Subject: L-2016-083-Voluntary Submittal of Exemption Request and Design Change Description for Departure from AP1000 DCD Revision 19 to Address Compliance With IEEE 603-1991

Proposed Turkey Point Units 6 and 7

Docket Nos. 52-040 and 52-041

**Design Change to Address Compliance with
IEEE 603-1991 for Source Range Neutron Flux Doubling
Revisions to the Turkey Point Units 6 & 7 COL Application**

Figure 7.2-1 (Sheet 3 of 21)

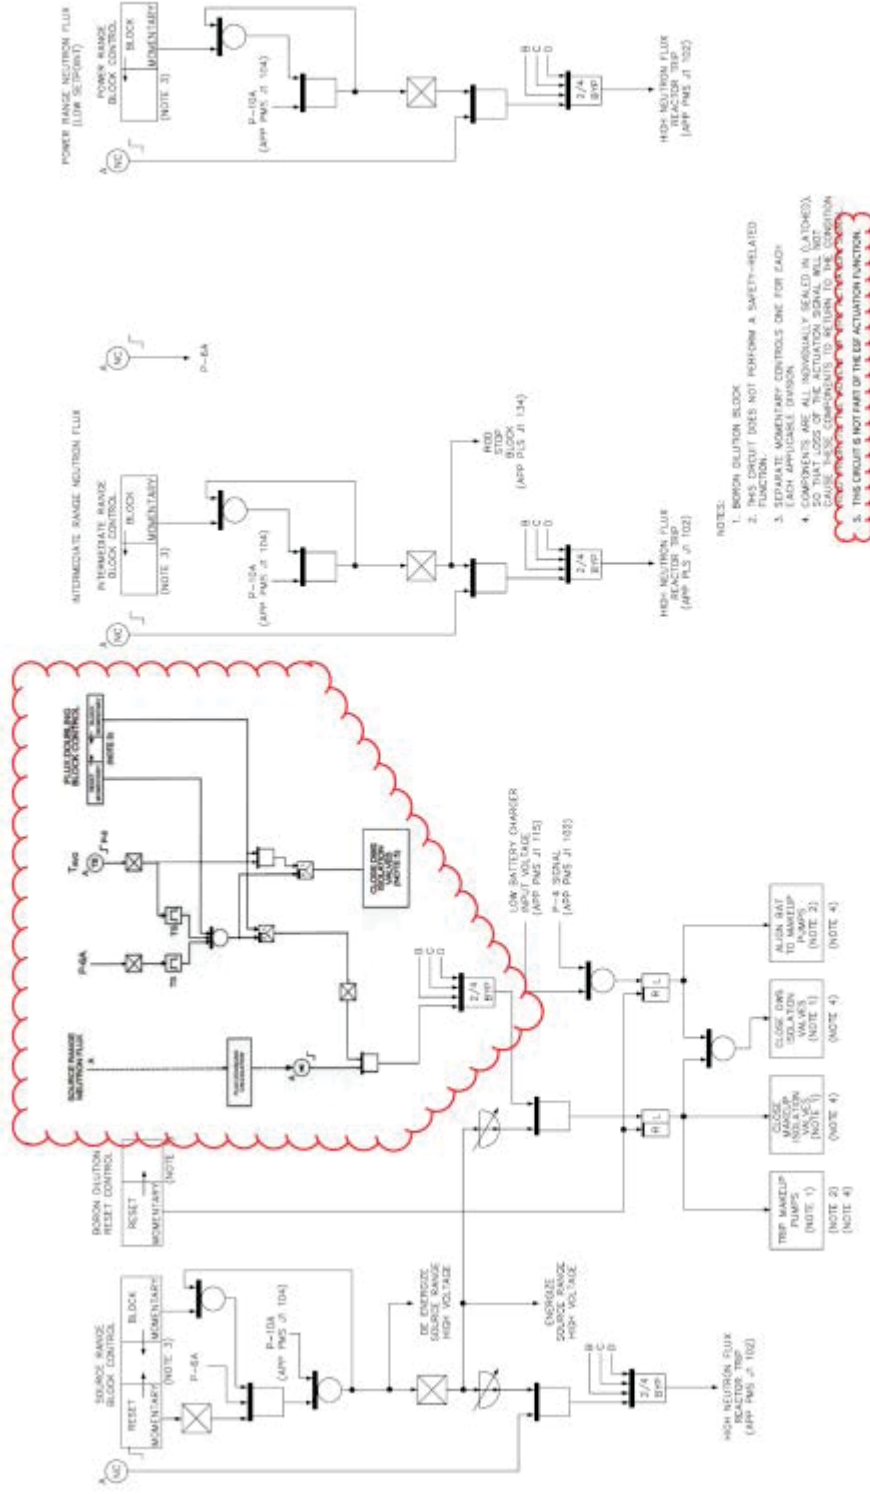
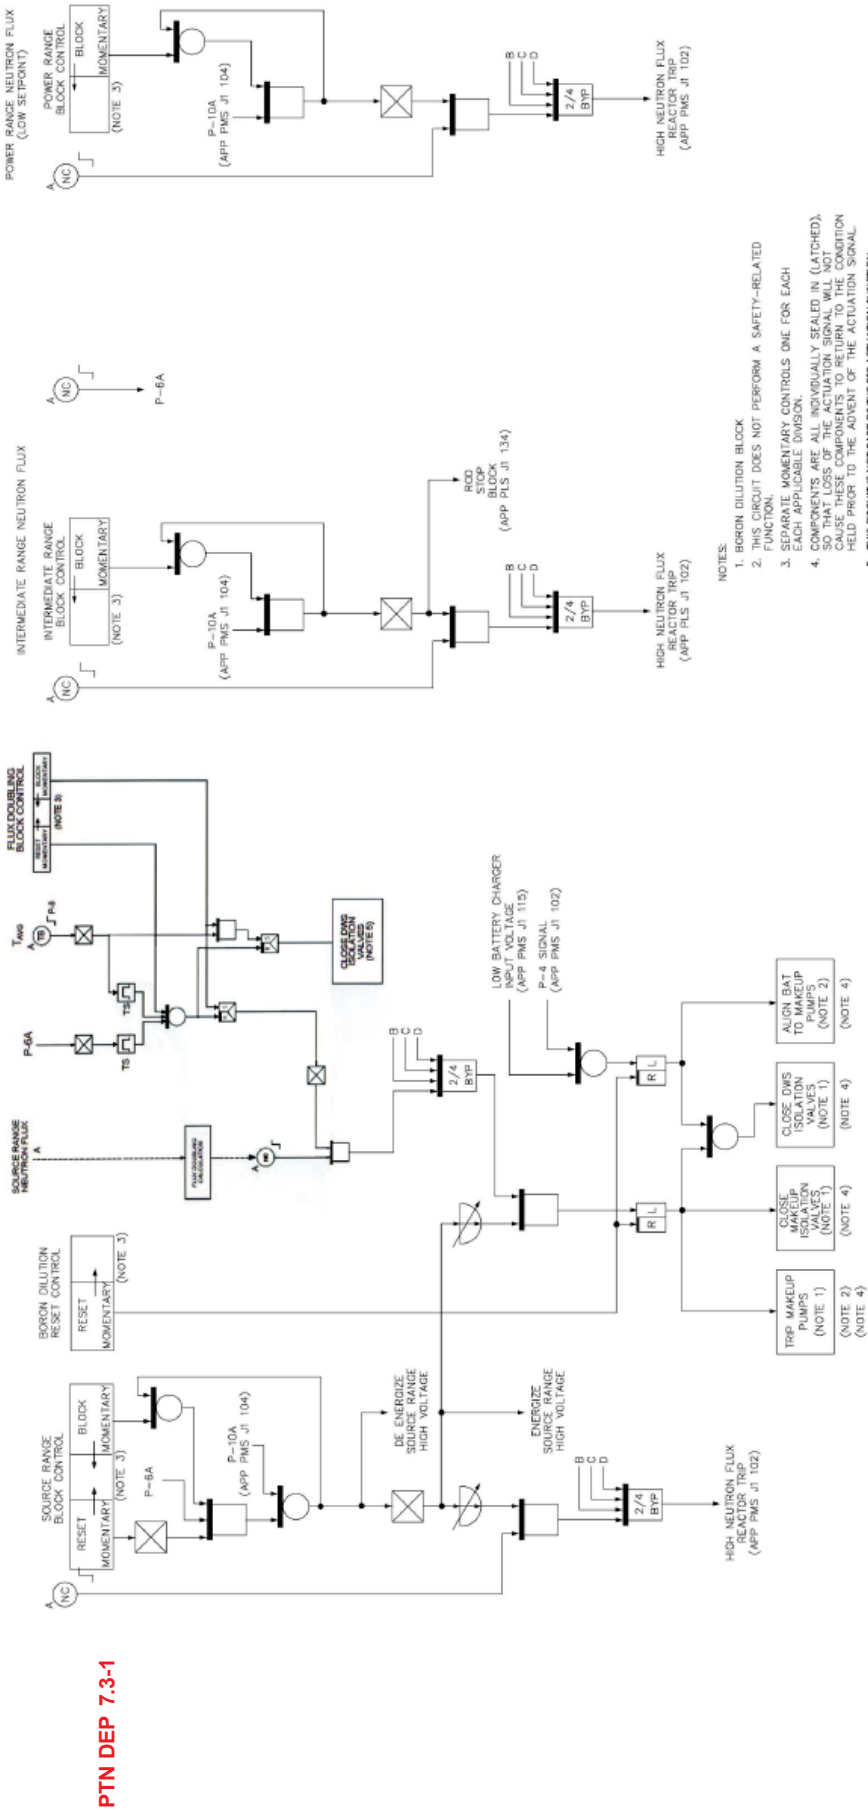
- Figure 7.2-1 (Sheet 3 of 21); Add logic for condition when source range flux doubling signal may be manually blocked and automatically reset.
- Section 7.3.1.2.14, Boron Dilution Block; Revise discussion of conditions when the source range flux doubling signal may be manually blocked and when it is reinstated.

2.. COLA Part 2, FSAR Chapter 7 is revised with the addition of Figure 7.2-1R with annotation PTN DEP 7.3-1 as follows
(departure from DCD Figure 7.2-1 (Sheet 3 of 21):

- 1) Add a new permissive, P-8, to permit blocking the flux doubling logic during reactor startup. (P-8 provides the logical permissive input to the PMS. P-8 is set to 551°F Reactor Coolant System (RCS) temperature, the minimum temperature for criticality.)

- 2) Add logic that will cause the PMS to force CVS valves 136A and 136B closed if the flux doubling logic is blocked when reactor temperature is less than P-8. (This ensures a permissible condition exists before flux doubling is bypassed below P-8, which is one option from IEEE 603-991, the other being to perform the appropriate safety functions.)

- 3) When RCS temperature is below P-8, reset the flux doubling logic if CVS valves 136A and 136B are opened.
- 4) Add an additional reset of source range flux doubling logic when RCS temperature falls below P-8. Existing PMS design resets flux doubling logic when neutron flux decreases below P-6.
